# WENONA PROJECT ARCHIMEDES

WENONA SCHOOL PTY LTD

## MARK-UP OF SECTION 96 INCLUSIONS

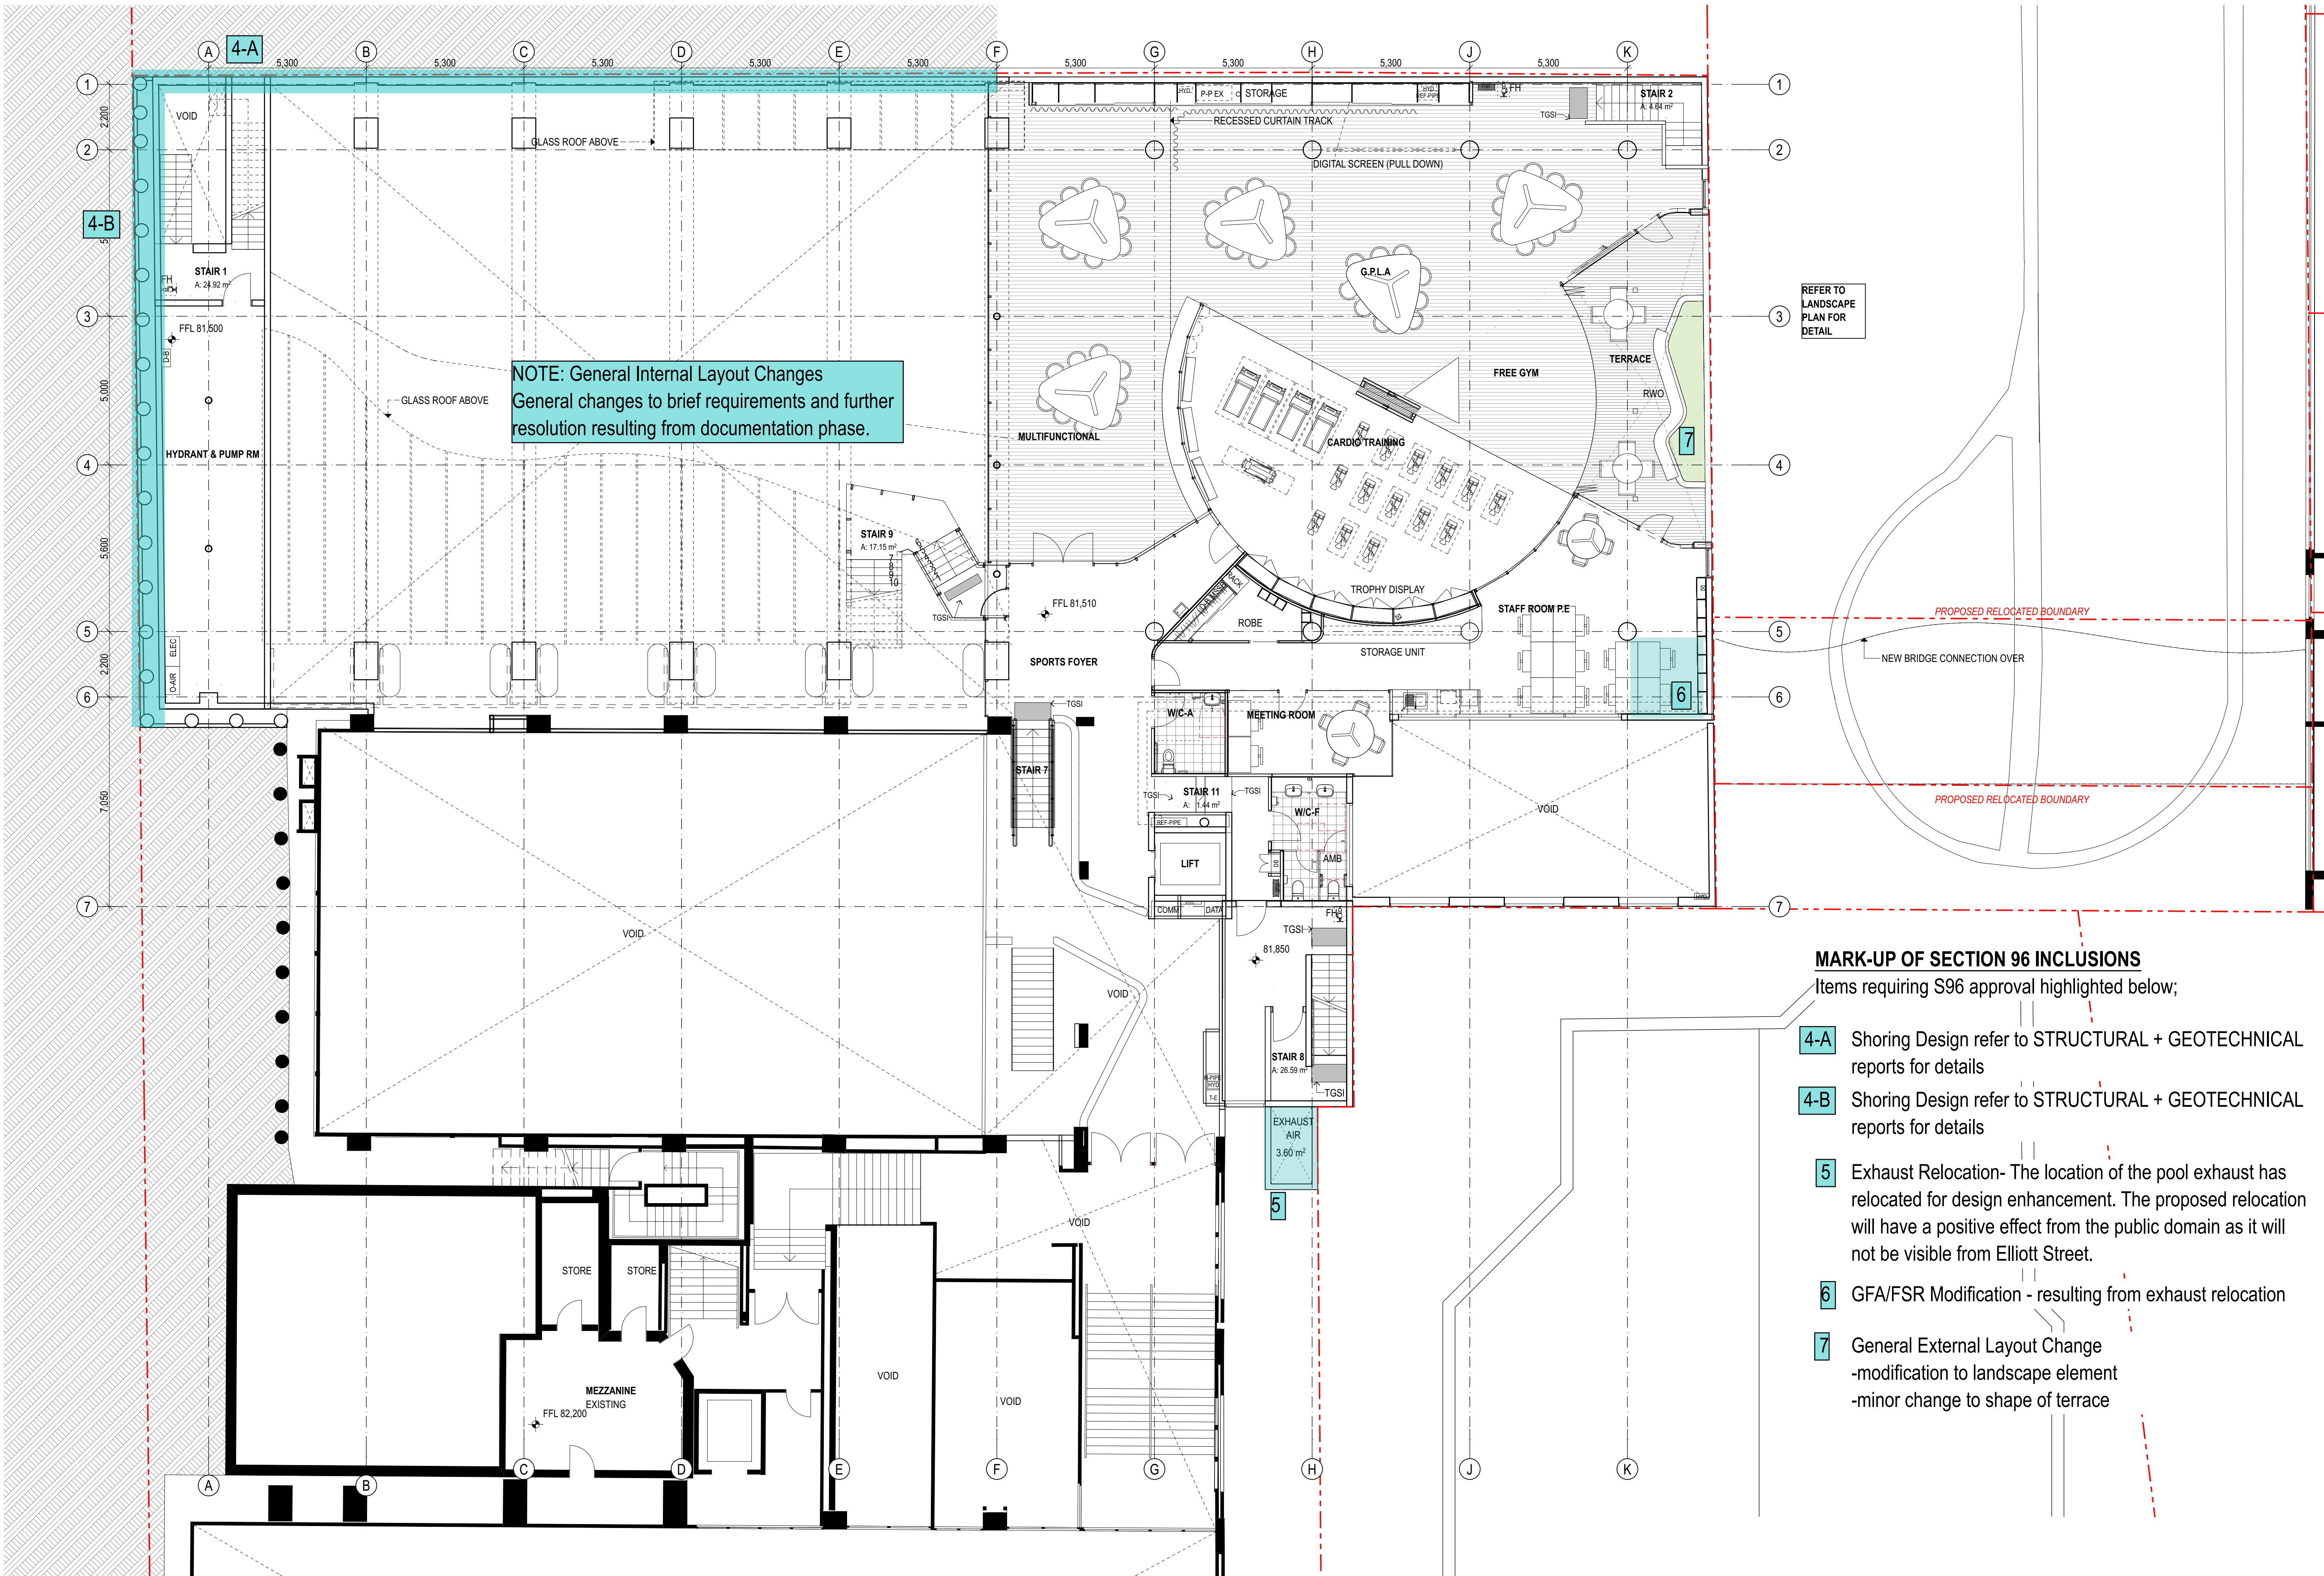
Items requiring S96 approval highlighted below;

- 4-A** Shoring Design refer to STRUCTURAL + GEOTECHNICAL reports for details
- 4-B** Shoring Design refer to STRUCTURAL + GEOTECHNICAL reports for details
- 5** Exhaust Relocation- The location of the pool exhaust has relocated for design enhancement. The proposed relocation will have a positive effect from the public domain as it will not be visible from Elliott Street.
- 6** GFA/FSR Modification - resulting from exhaust relocation
- 7** General External Layout Change  
-modification to location of bike racks and garbage overflow  
-access hatch provided for maintenance of plant room below

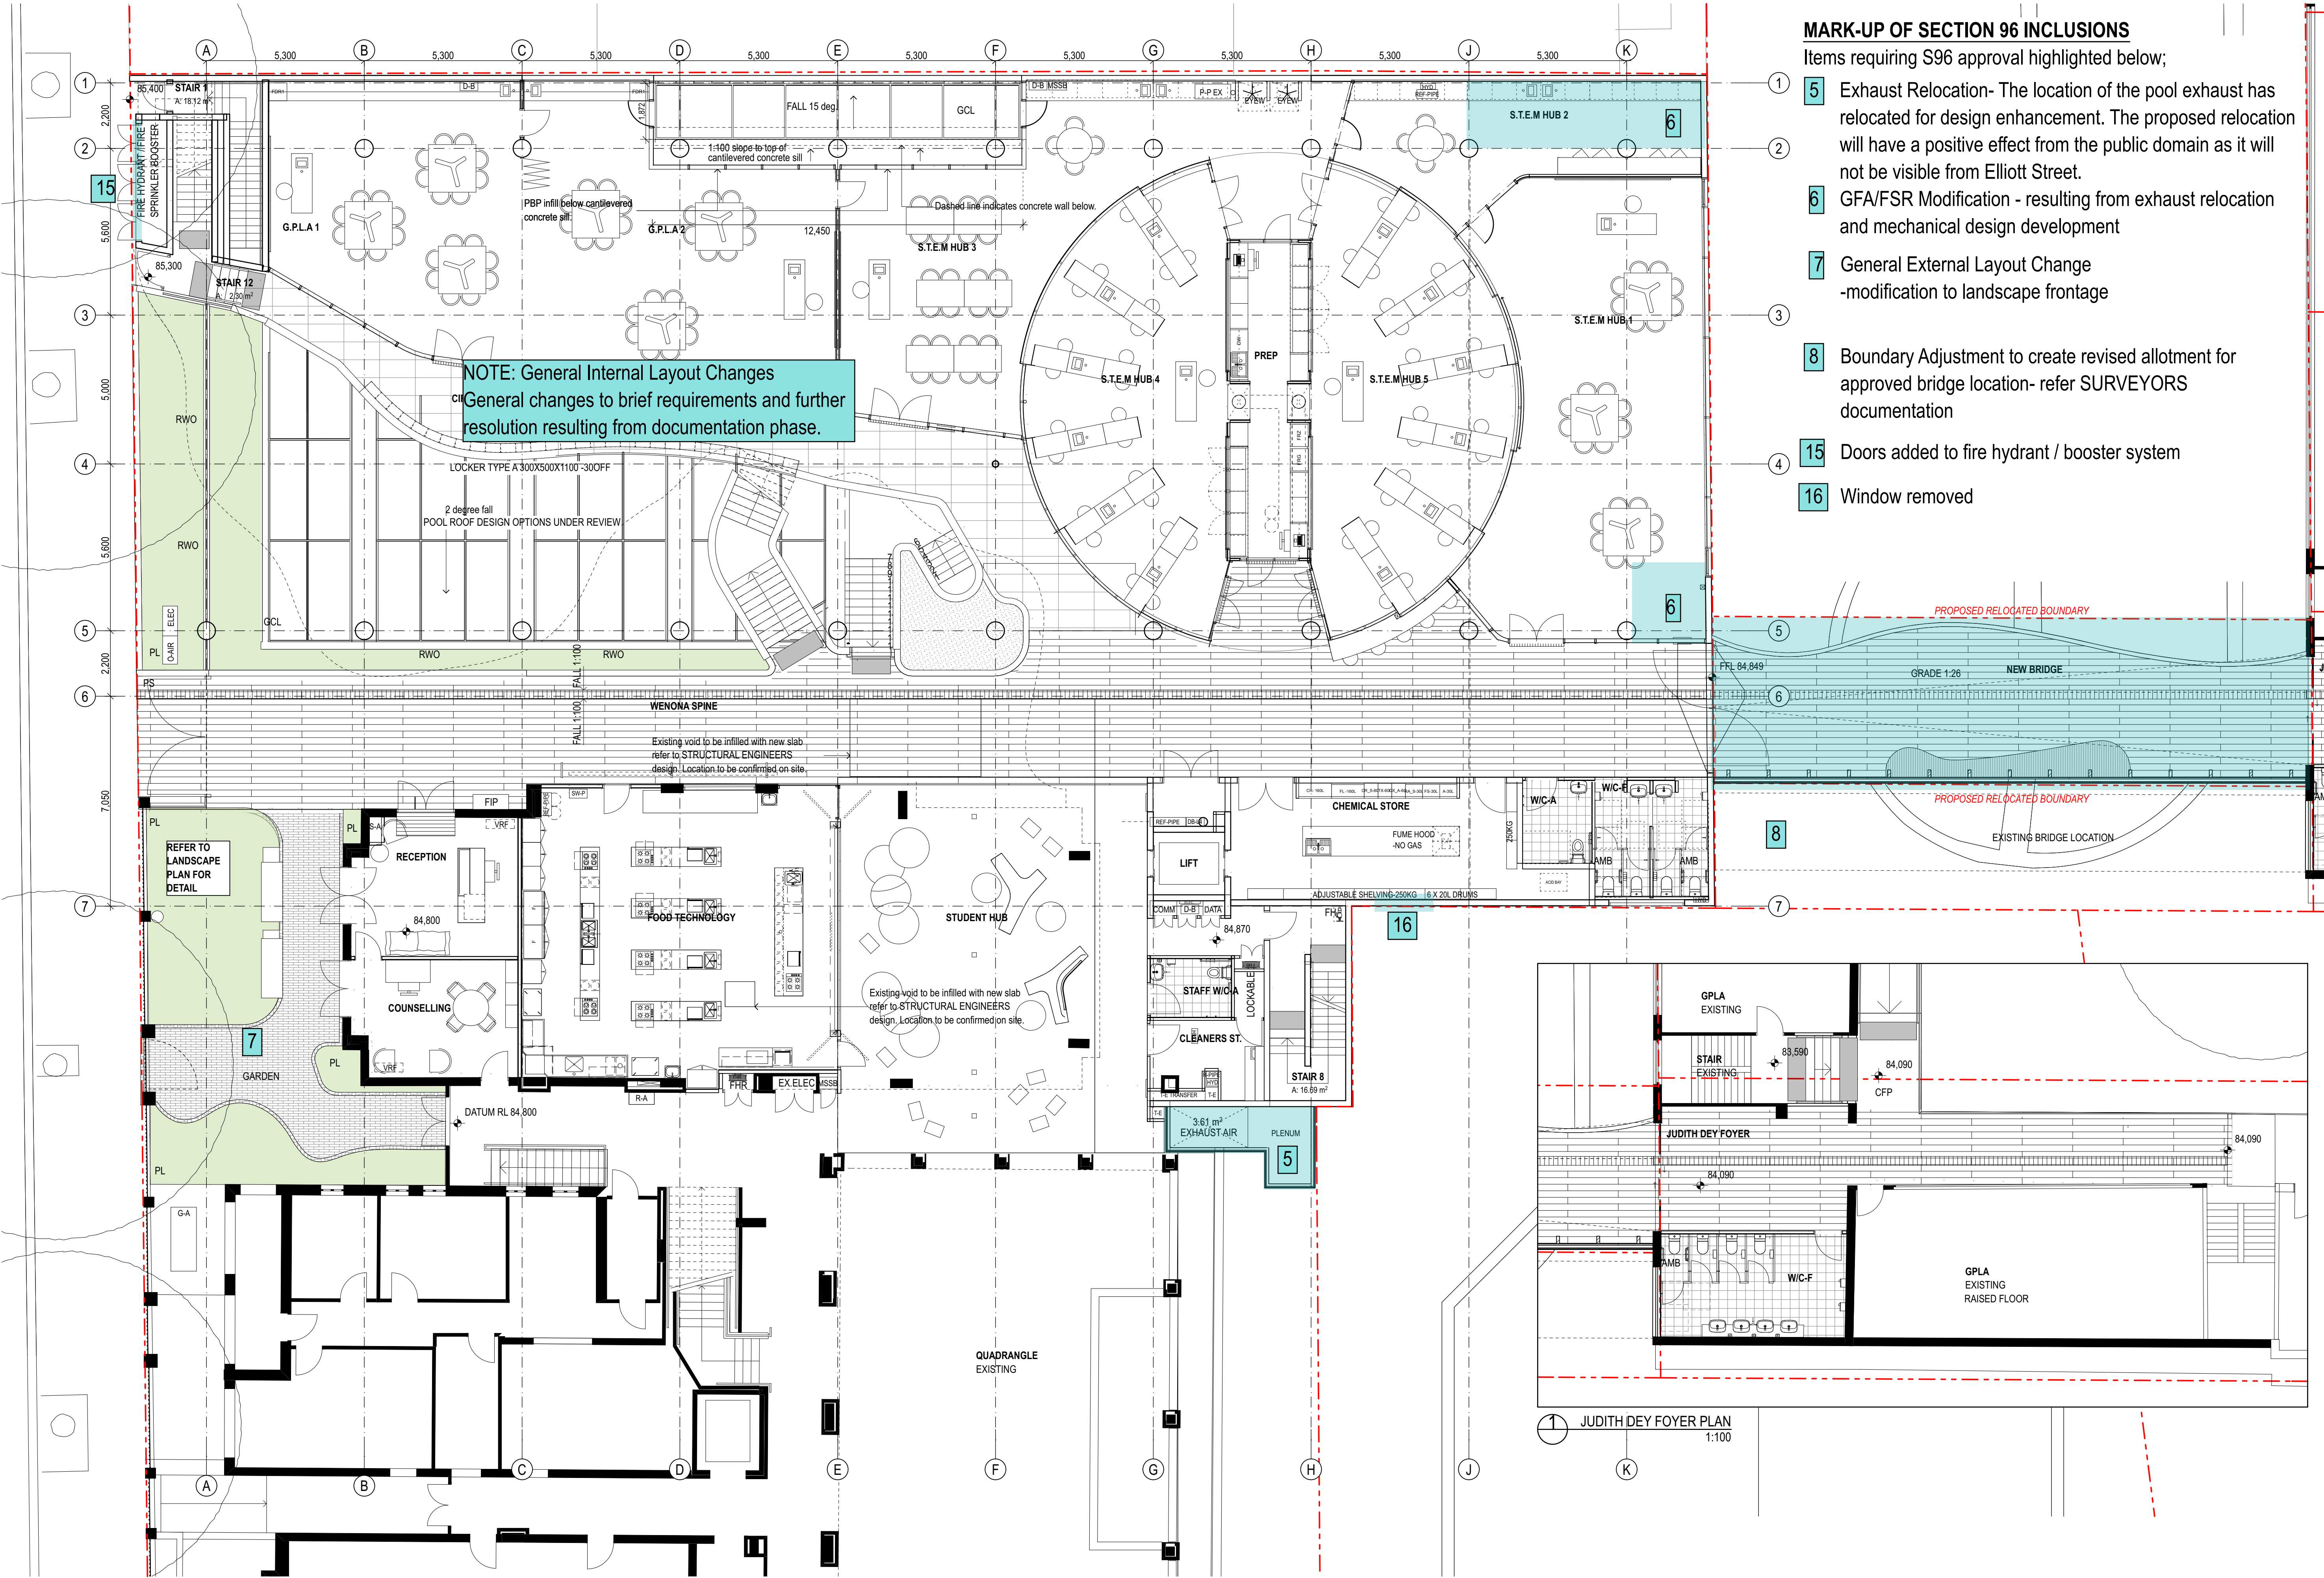
Items requiring S96 approval highlighted below;

- 4-A** Shoring Design refer to STRUCTURAL + GEOTECHNICAL reports for details
- 4-B** Shoring Design refer to STRUCTURAL + GEOTECHNICAL reports for details
- 5** Exhaust Relocation- The location of the pool exhaust has relocated for design enhancement. The proposed relocation will have a positive effect from the public domain as it will not be visible from Elliott Street.
- 6** GFA/FSR Modification - resulting from exhaust relocation
- 7** General External Layout Change  
-modification to landscape element  
-minor change to shape of terrace
